# Service Bulletin

**SUBJECT:** Service Update for Inventory Vehicles Only  
Transmission Snap Ring Misalignment  
Expires September 30, 2014

**MODELS:** 2013 Buick Regal, LaCrosse  
2013 Chevrolet Malibu  
Equipped with 6T40 Automatic Transmission (MHH)

3613040

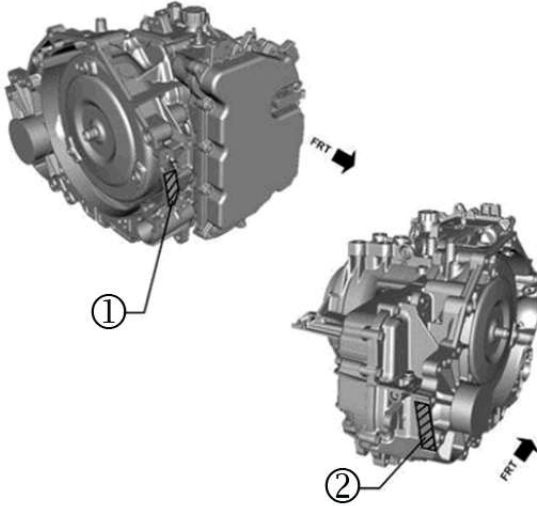
**Note:** A VIN derivative is required to be permanently engraved on the new transmission prior to installation. Refer to the illustration above for VIN engraving location points. Select one of the locations to engrave the required characters. VIN derivatives must be formatted as indicated below (# = last eight characters of the VIN).

Buick Regal and LaCrosse: 1J\*4#####B

Chevrolet Malibu: 1J\*1#####B
